City of Ketchum

Recommendation to approve the Mindbender Condominiums Subdivision Final Plat

A PLAT SHOWING MINDBENDER CONDOMINIUMS

IN RE:)	
)	
Mindbender Condominium Subdivision)	KETCHUM CITY COUNCIL
Final Plat)	FINDINGS OF FACT, CONCLUSIONS OF LAW, AND
Date: December 7, 2020)	DECISION
)	
File Number: P20-115)

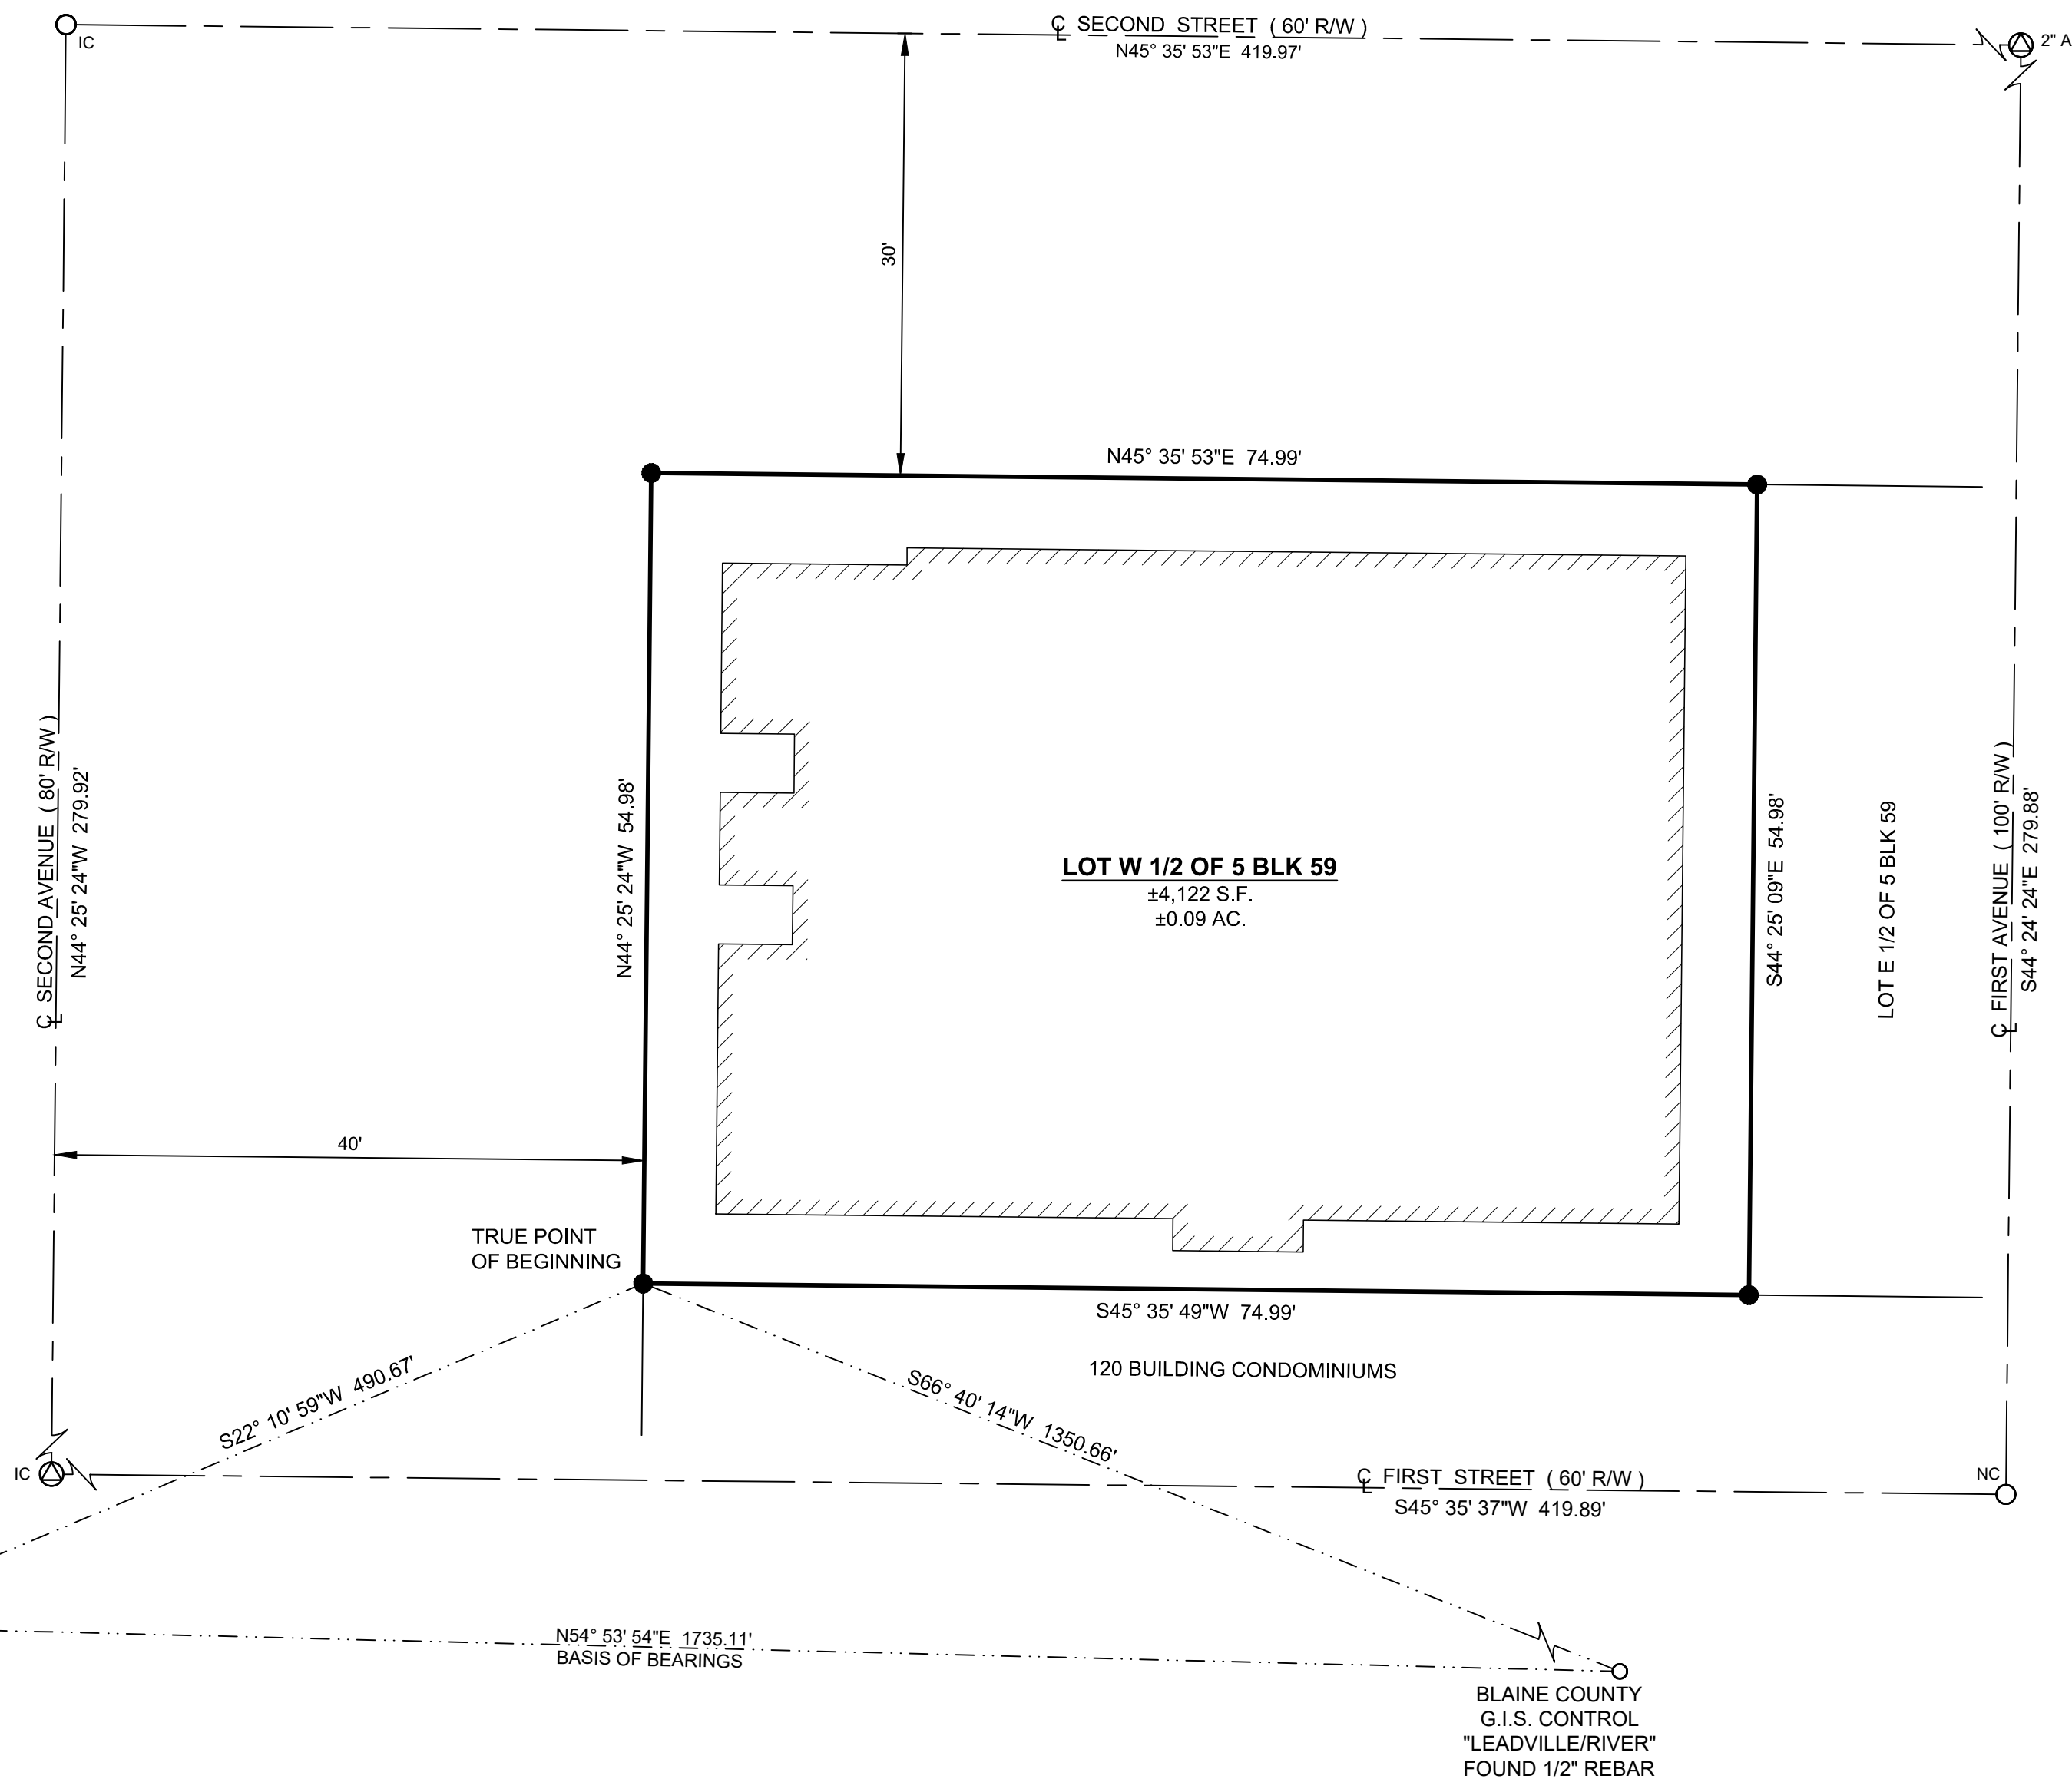
2. The recorded plat shall show a minimum of two Blaine County Survey Control Monuments with ties to the property and an inverse between the two monuments. The Survey Control Monuments shall be clearly identified on the face of the map.

UNITS 101 & 102 (1ST FLOOR)

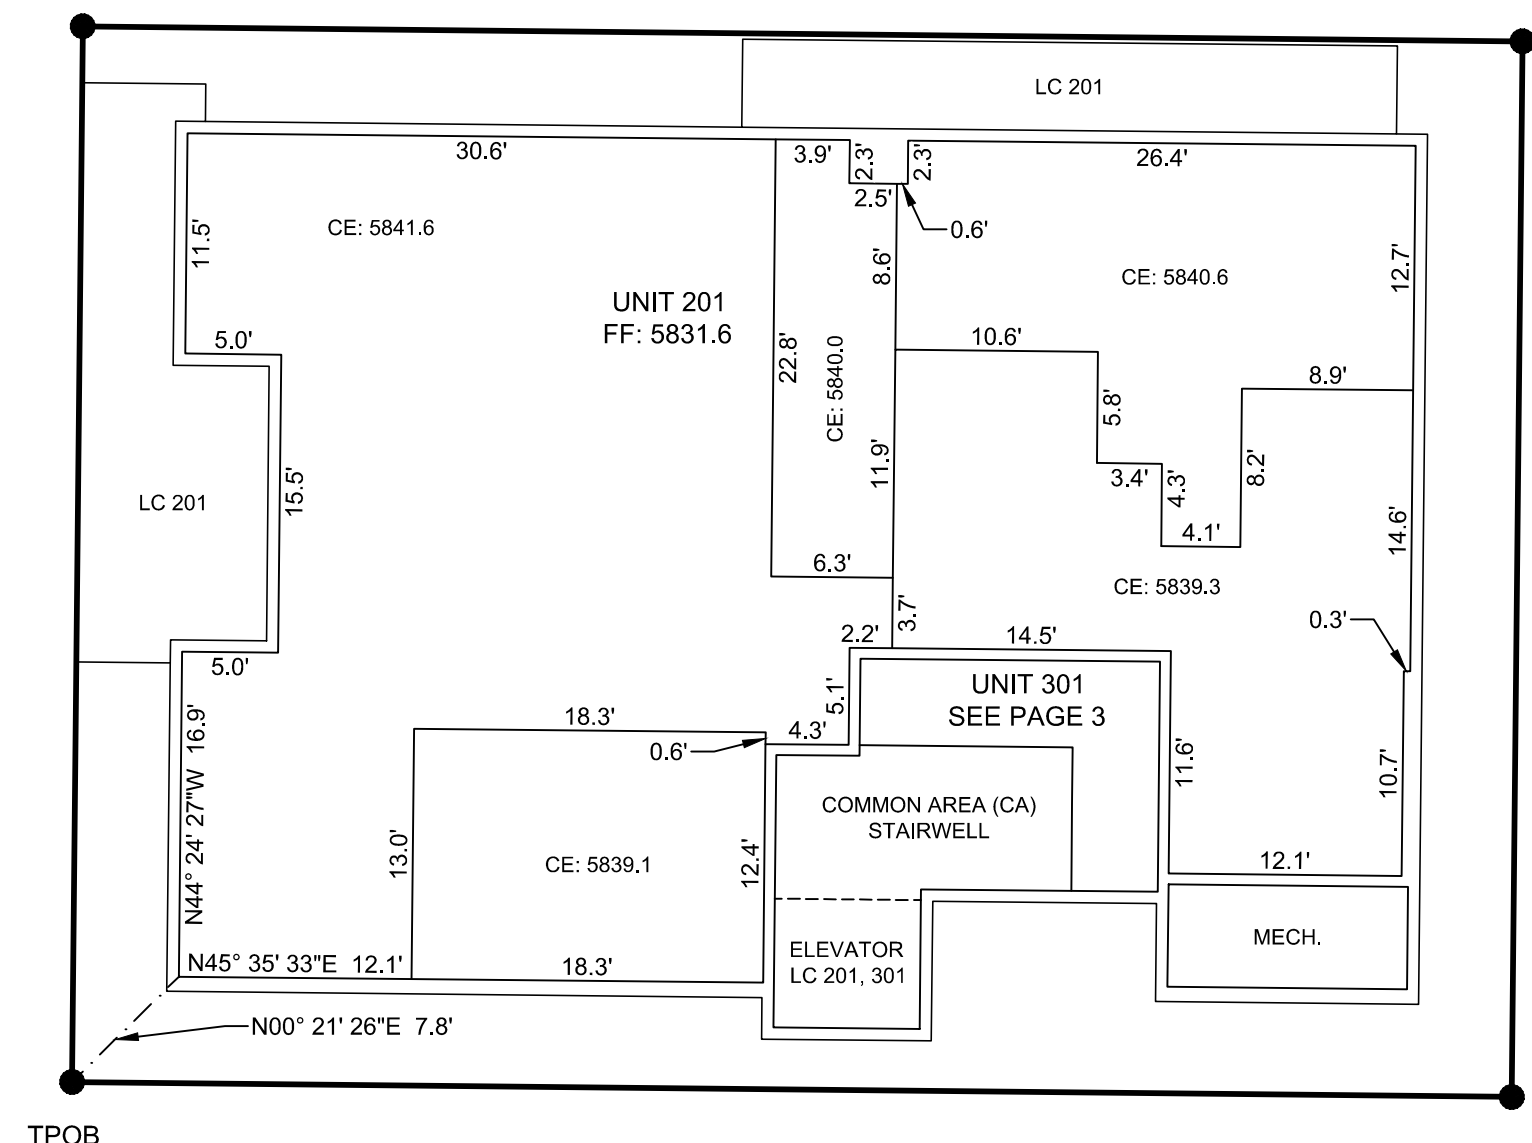
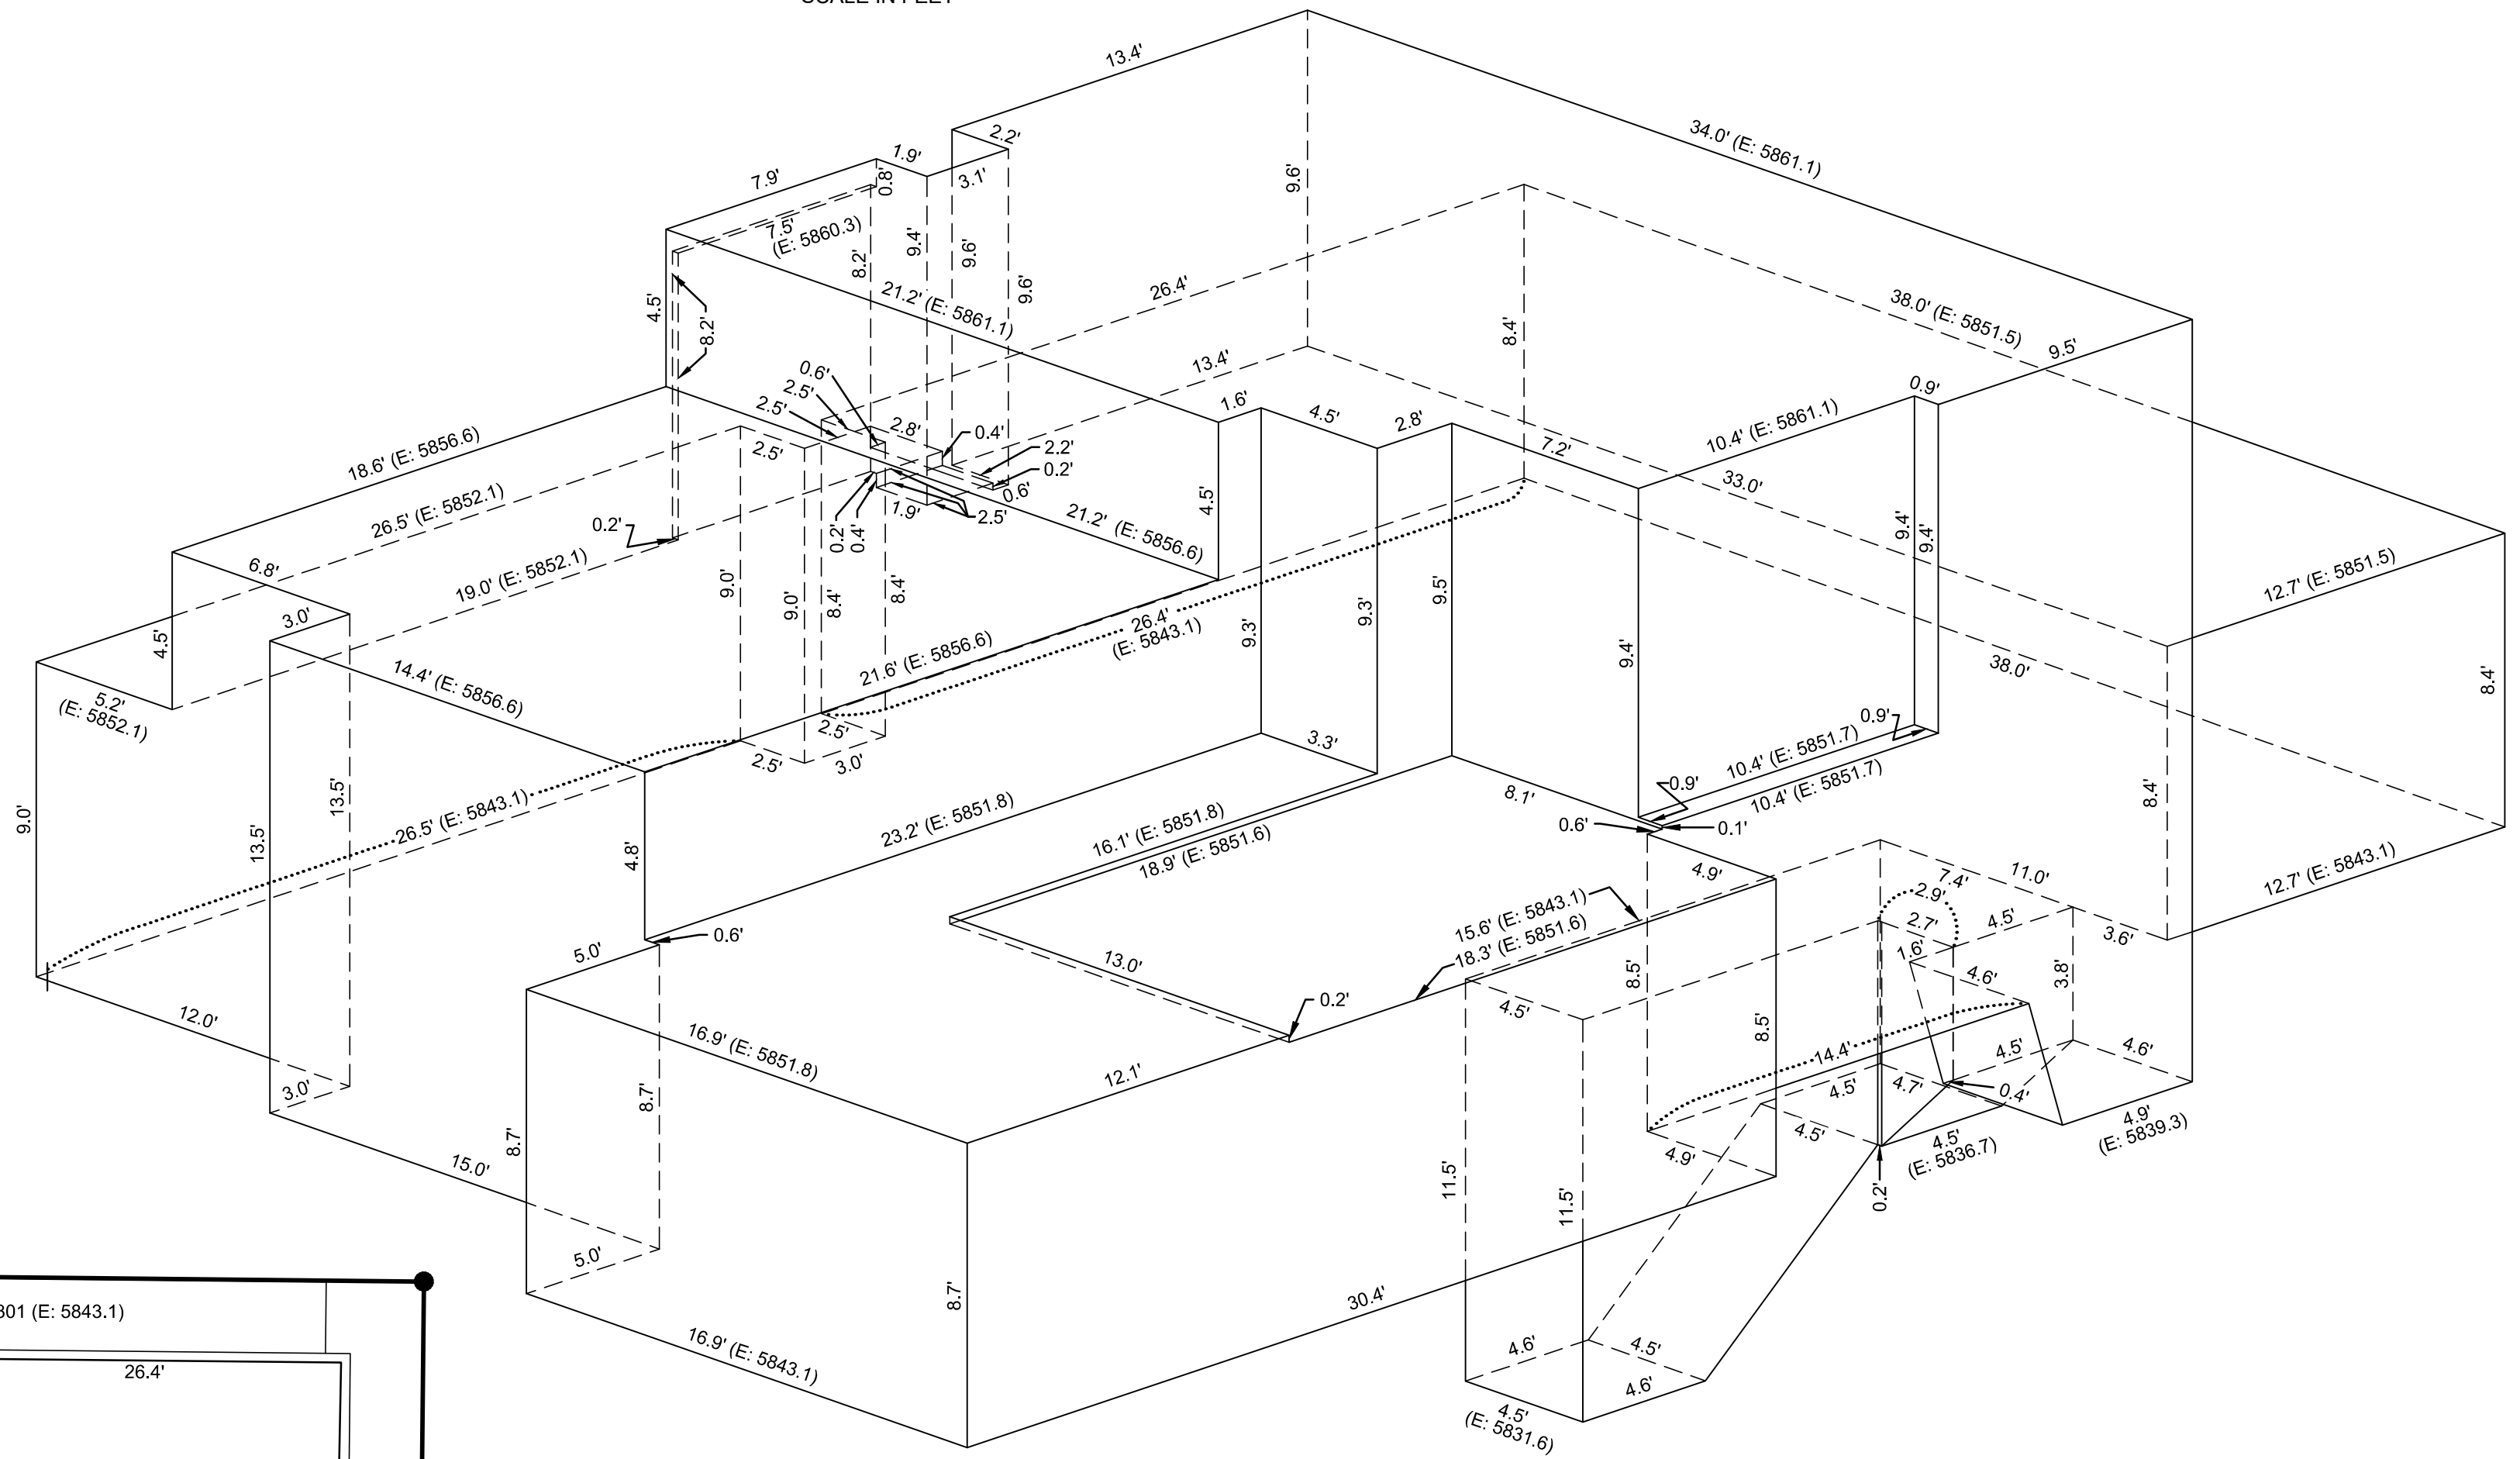
<i>Staff Comments</i>	<i>Limited Common Area storage rooms and/or garages are indicated on the plat for all units - Units 101, 102, 201 and 301.</i>
<input checked="" type="checkbox"/>	<input type="checkbox"/>	<input type="checkbox"/>	16.04.070.F	<p>Maintenance Building: A maintenance building or room shall be provided of adequate size and location for the type and size of the condominium project for storage of maintenance equipment and supplies for common areas.</p>
			<i>Staff Comments</i>	<i>Mechanical rooms are indicated on the plat.</i>
<input checked="" type="checkbox"/>	<input type="checkbox"/>	<input type="checkbox"/>	16.04.070.G	<p>Open Space: The subdivider shall dedicate to the common use of the homeowners adequate open space of such shape and area usable and convenient to the residents of the condominium subdivision. Location of building sites and common area shall maximize privacy and solar access.</p>

<i>Staff Comments</i>	<i>Units 101 and 102 have outdoor spaces located at the entries of the units, albeit small. Units 201 and 301 have extensive outdoor deck space indicated as Limited Common areas associated with these units.</i>
<input checked="" type="checkbox"/>	<input type="checkbox"/>	<input type="checkbox"/>	16.04.060.H	<p>General Applicability: All other provisions of this chapter and all applicable ordinances, rules and regulations of the city and all other governmental entities having jurisdiction shall be complied with by condominium subdivisions.</p>
